CONCEPTUAL
SCHEME
December 2016

*Amended April
2022*

DRAFT AMENDMENT:

April 7, 2022

Figure 1: Design Principles

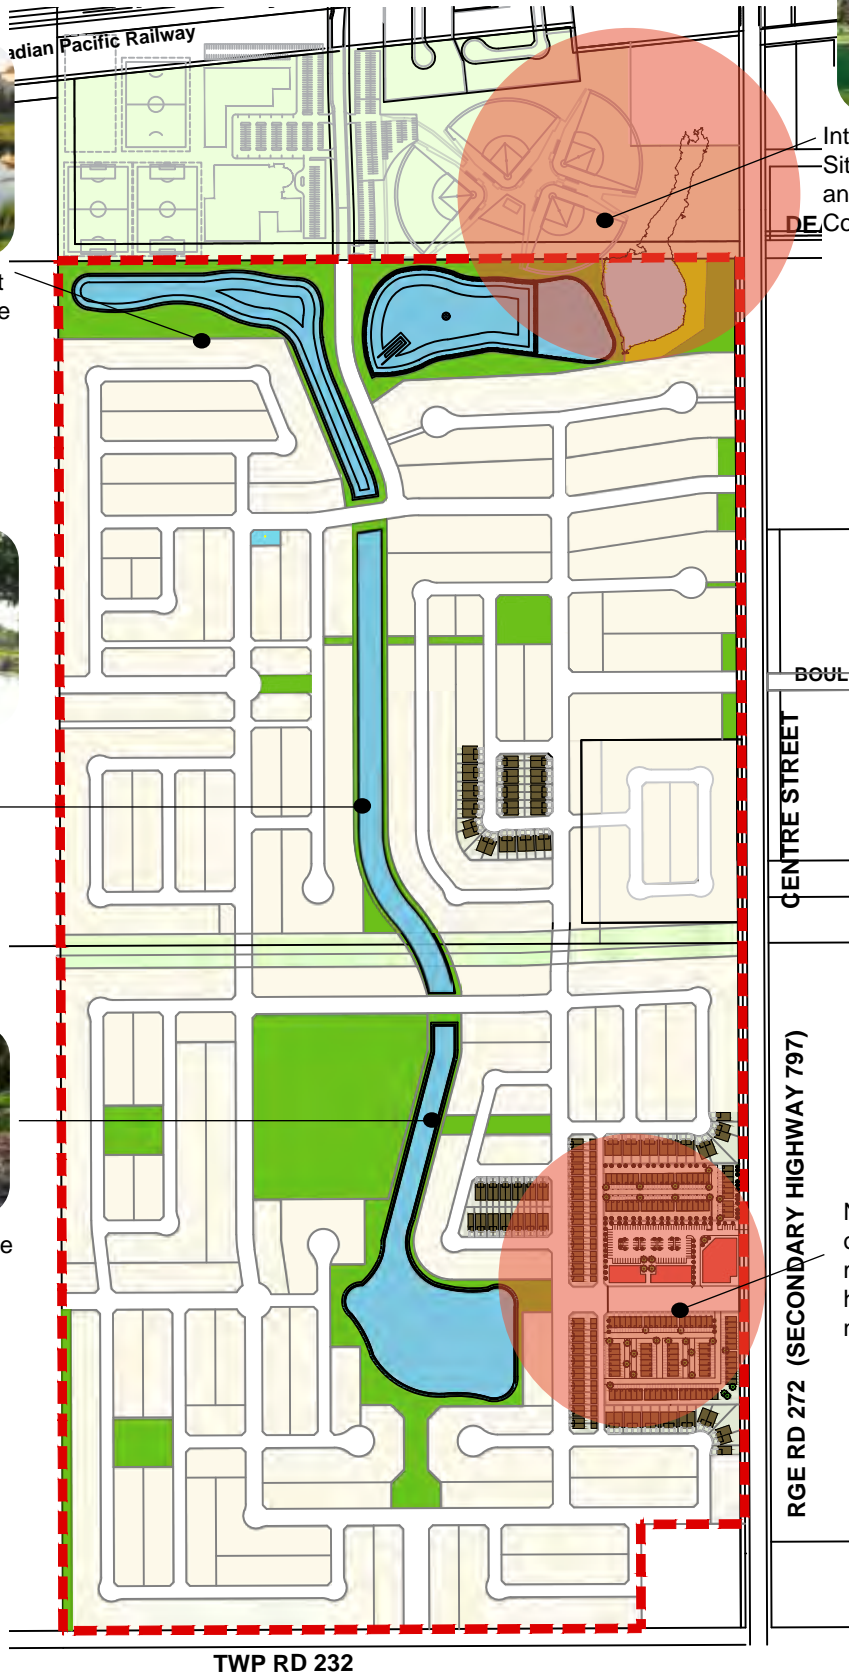
REVISED FIGURE

Figure 8: Land Use Concept

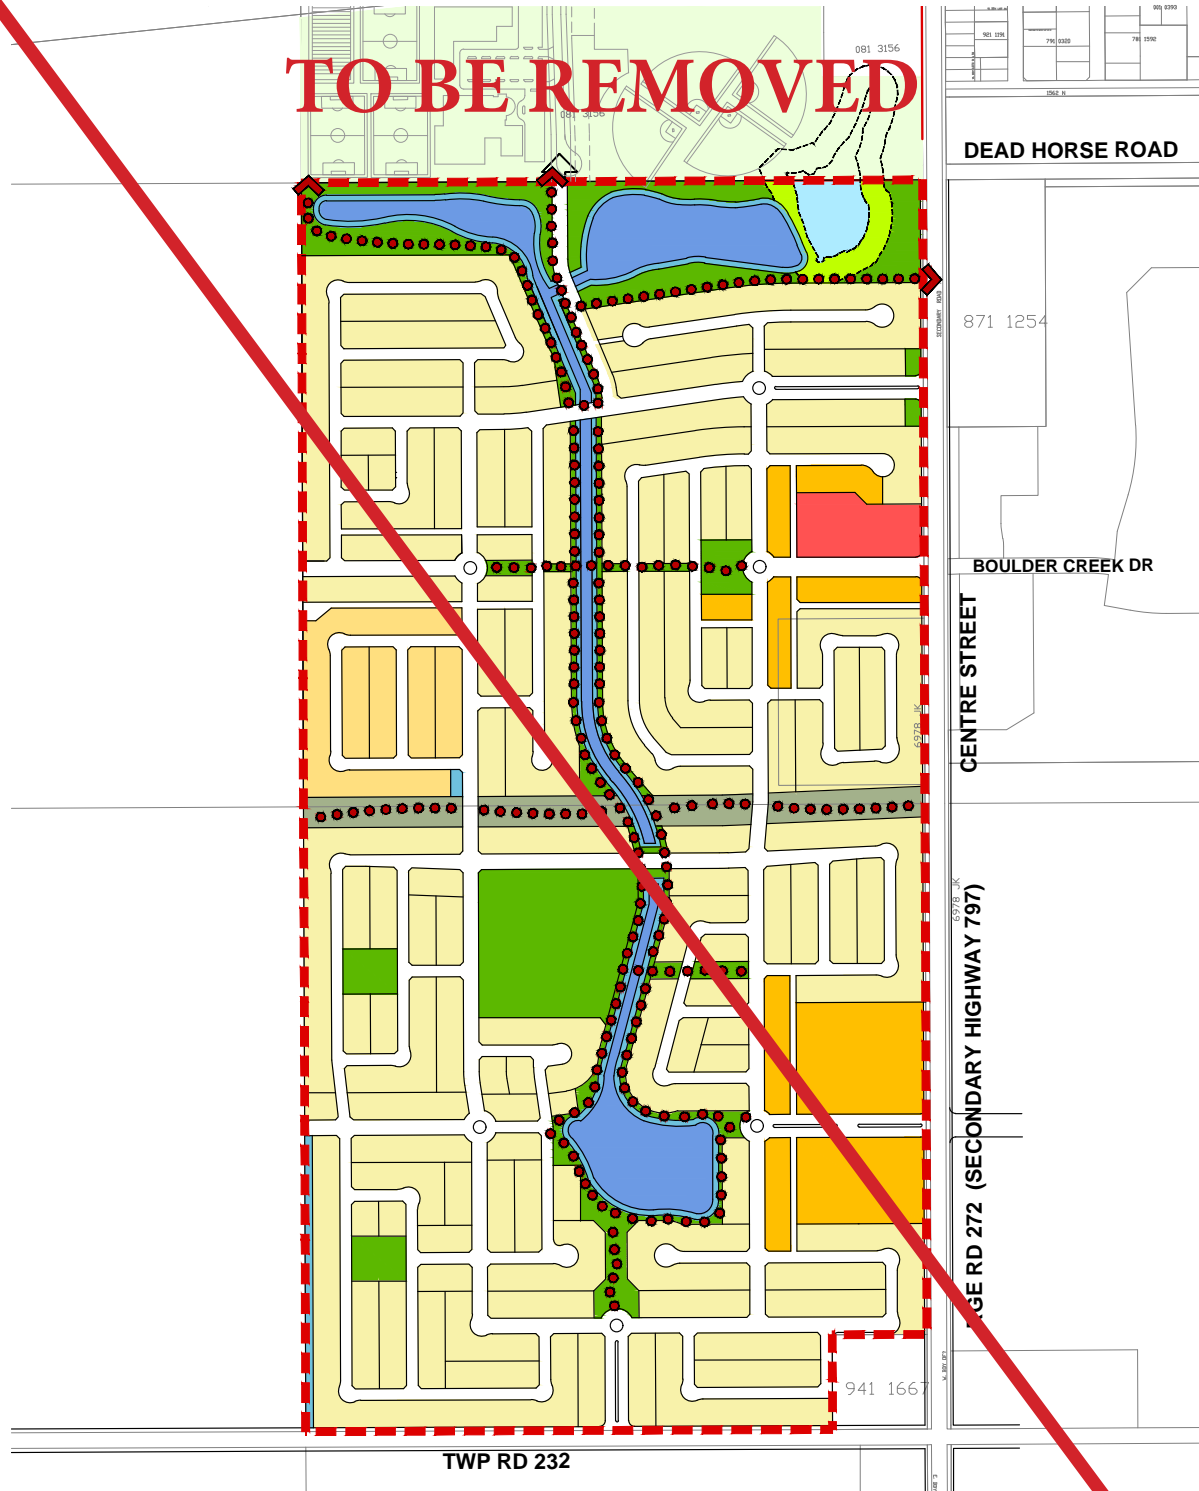
REVISED FIGURE

North Neighbourhood Centre Conceptual Illustration

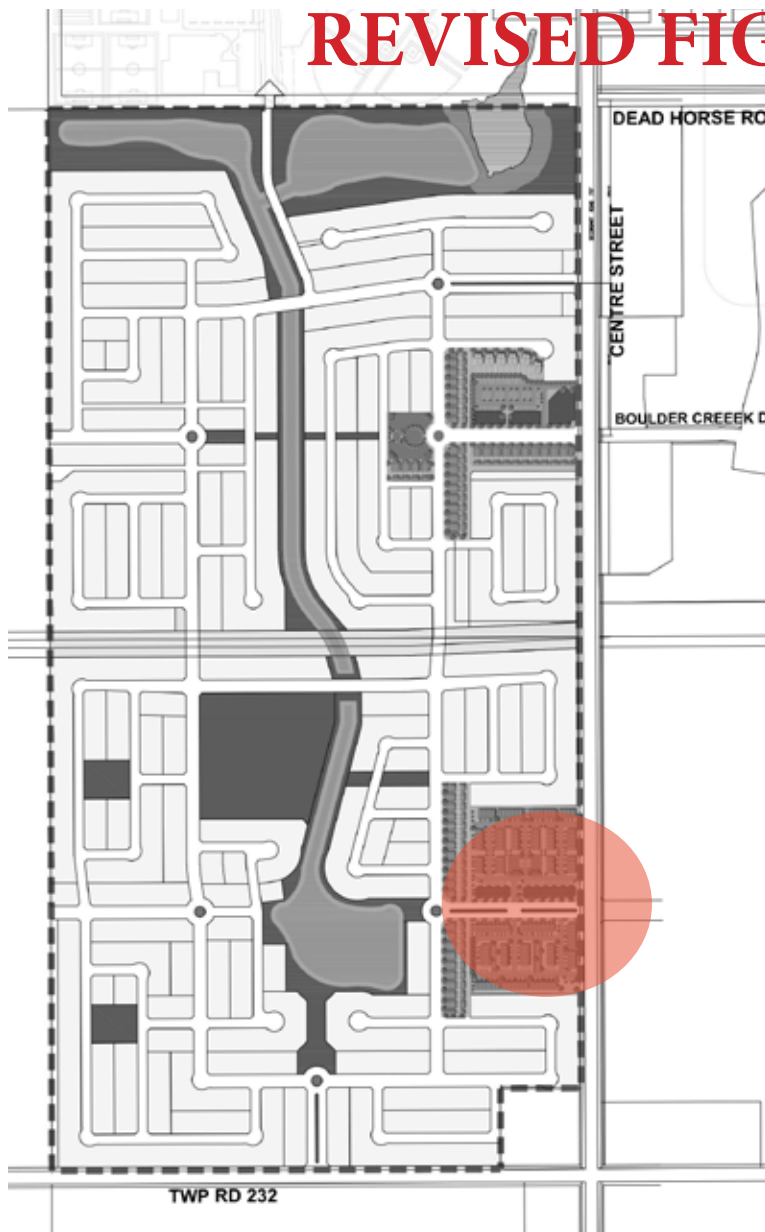
TO BE REMOVED

TO BE REMOVED

South Neighbourhood Centre Conceptual Illustration

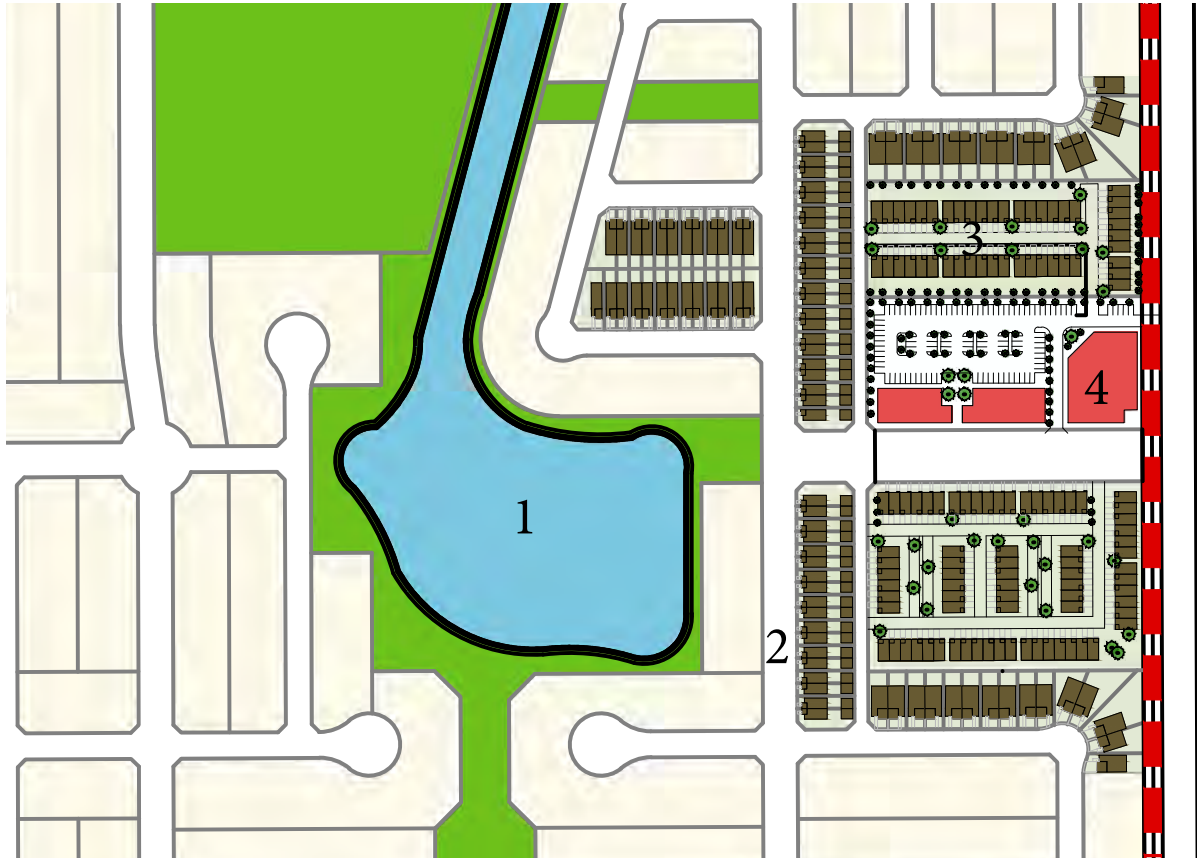
REVISED FIGURE

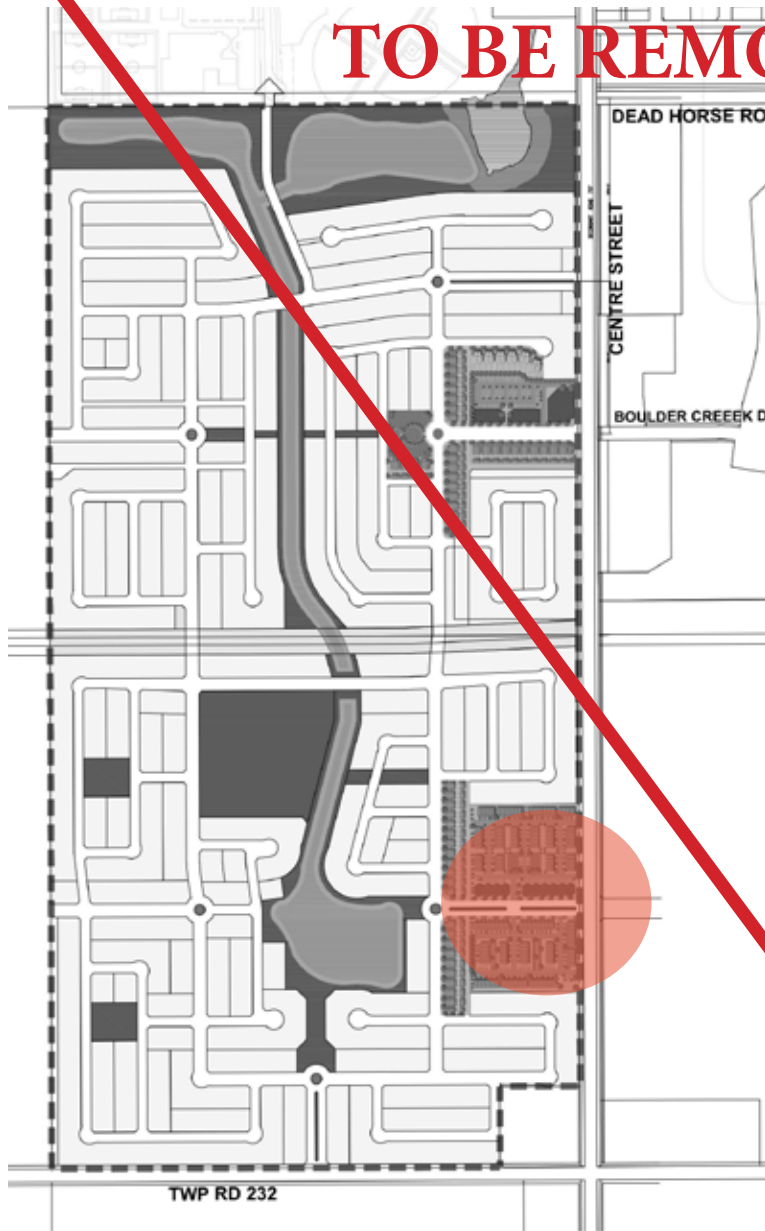
TO BE REMOVED
